Subject: Review of Risk Factors for Line 1600 ("The Kiefner Report"), Attachment C.

SAN DIEGO GAS & ELECTRIC COMPANY SOUTHERN CALIFORNIA GAS COMPANY PIPELINE SAFETY & RELIABILITY PROJECT (PSRP)

(A.15-09-013) (DATA REQUEST ORA-69)

Below is Figure 11, which includes a pressure test of 1200 psig for purposes of this data request response.

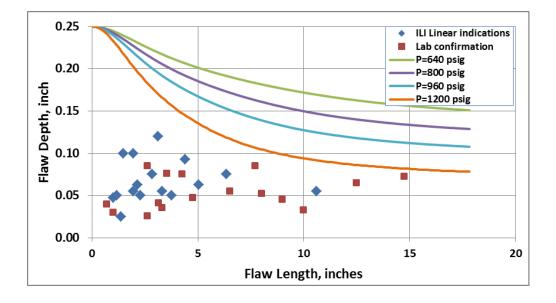
Provide an updated version of Figure 11 that includes a pressure test of 1200 psig.

Below is Figure 13, which includes a pressure test of 1200 psig for purposes of this data request response.

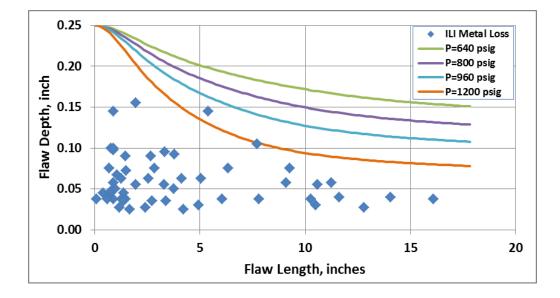
Provide an updated version of Figure 13 that includes a pressure test of 1200 psig.

a. Below is Figure 14 that is 2 dimensional, rather than 3 dimensional.

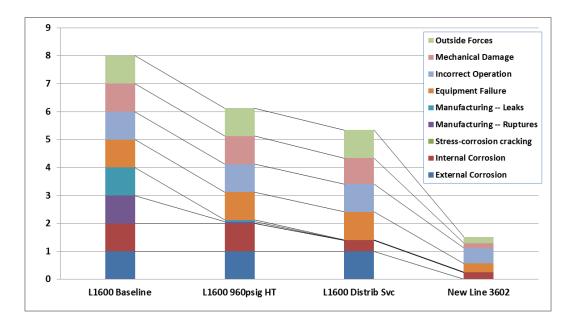
- a. Provide a copy of Figure 14 that is 2 dimensional, rather than 3 dimensional.
- b. Provide an Excel spreadsheet that contains each of the underlying data points used to generate Figure 14.

Why does the Figure 14 hydro test of Line 1600 use a pressure test of 1200 psig, as compared to elsewhere where a pressure test of 960 psig is used?

This appears to be an inconsistency due to a miscommunication. The correct pressure test should be 960 psig and will be corrected in evidentiary hearings. The analysis was redone using a test pressure of 960 psig. As expected, there was less of a risk reduction than with a test pressure of 1200 psig but the change in risk score was very small, mainly due to the fact that SDG&E has also performed in-line inspections. The revised figure provided to the response to Question 30 reflects this correction.
